Venice Neighborhood Council

Land Use & Planning Committee (LUPC) STAFF REPORT

City Case No: DIR-2025-5824-CDP-MEL-HCA

Address of Project: 1139-1141 Harrison Ave
(between Van Buren Ave & Lincoln Blvd)

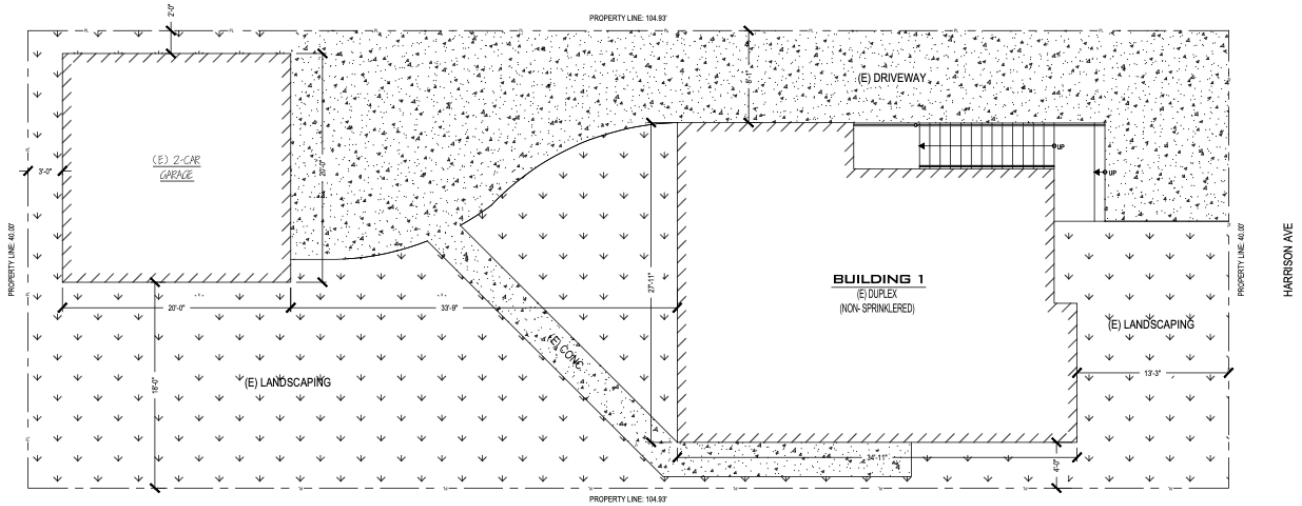
Note: **NO** photographs were included in the application documents — this image from Google Earth shows the existing view from E Harrison Avenue.

Also, **NO** existing elevations were included in the drawing set to facilitate comparison between the existing and the proposed.

SITE PLAN (PROPOSED)
SHOWING AREA OF WORK SCALE: 3/16"=1'-0"

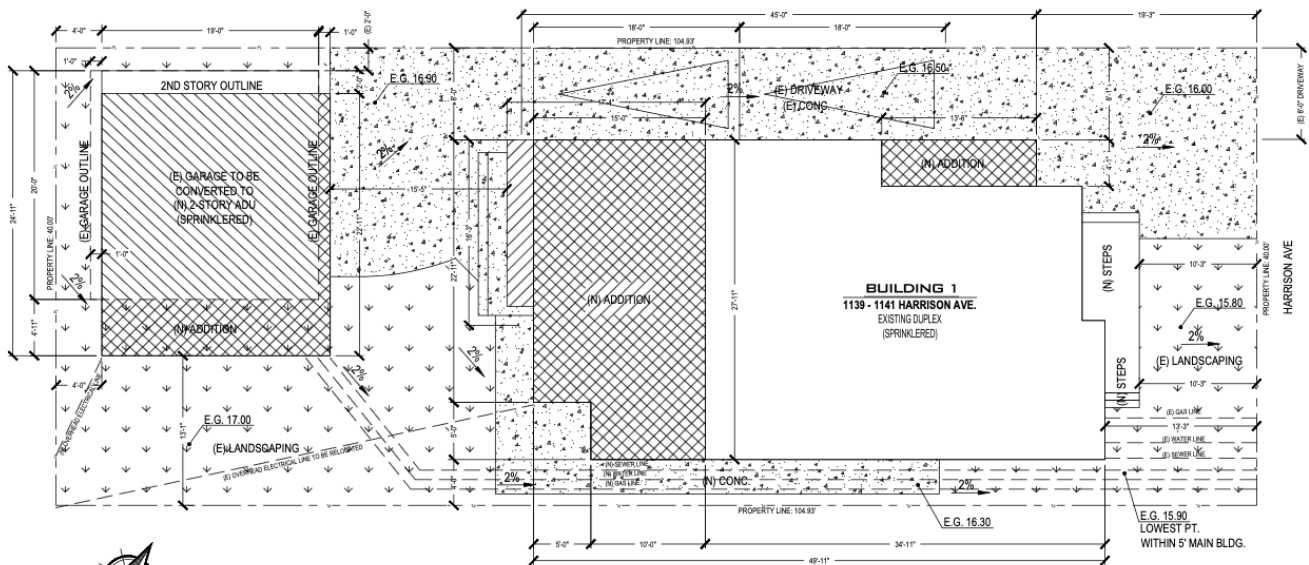
The significant increase in the volume of the existing building and additional two story ADU, produce a very condensed residential setting, with only two parking spaces in the driveway, which when used block access to the rear unit. The proposed fenestration shows windows looking into the adjacent sites, some only a few feet away from adjacent buildings. This is especially true for the ADU, as there is no alley. Moving the new perimeter wall one foot away from the property line to conform to a 4' setback requirement does not address this issue.

Note: the architect – Nicole Cannon, referenced in the application documents did not make the drawings, is a friend of the owner, but was not engaged to design the project (confirmed by DT / LUPC telecom with Nicole Cannon)

First Floor (Main House)

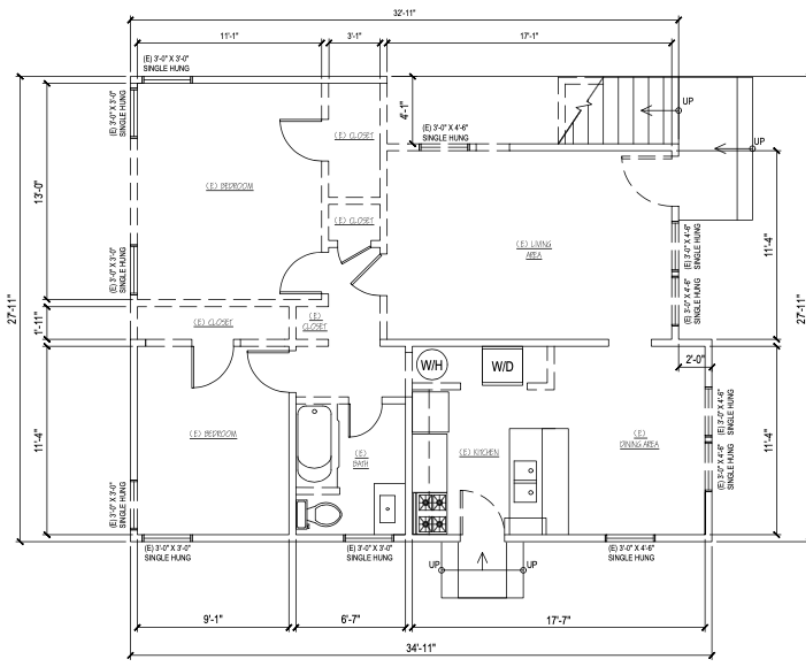
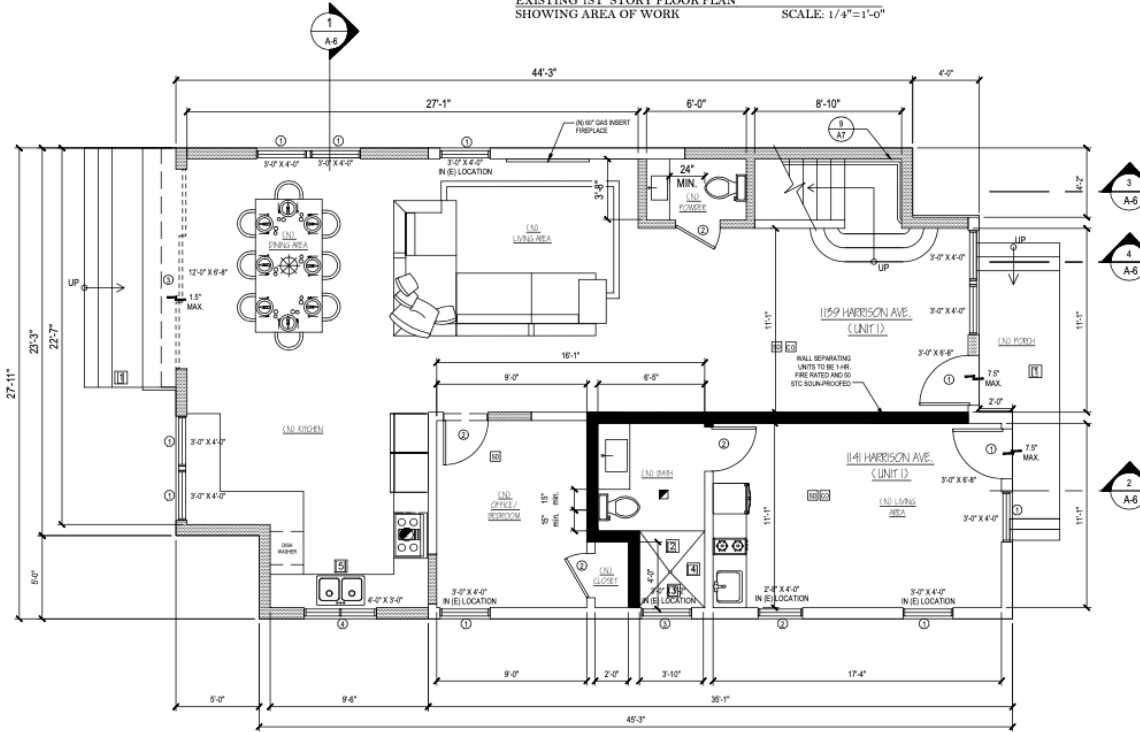
The single, nominally rentable, room, for the owner's son, with ensuite bathroom in the enlarged house is less than 250 sq.ft in area. This is shown with a 'kitchen' countertop, but as a rental unit is too small to be viable. It is, nevertheless, declared one part of a 'duplex'. Considering it as such seems unreasonable and appears to be a semantic 'sleight of hand', covering up the reality that this application is really a request for re-zoning from 'duplex' with a garage as described on ZIMAS to a single family home, with a detached ADU.

LUPC suggestions for follow up: Project should be resubmitted after it has been substantially redesigned with two units in the 'Main House' of similar floor area, retaining the use of that building as a 'Duplex' apartment building. Also, any and all overlooking concerns from perimeter windows in the 'Main House' and ADU should be addressed.
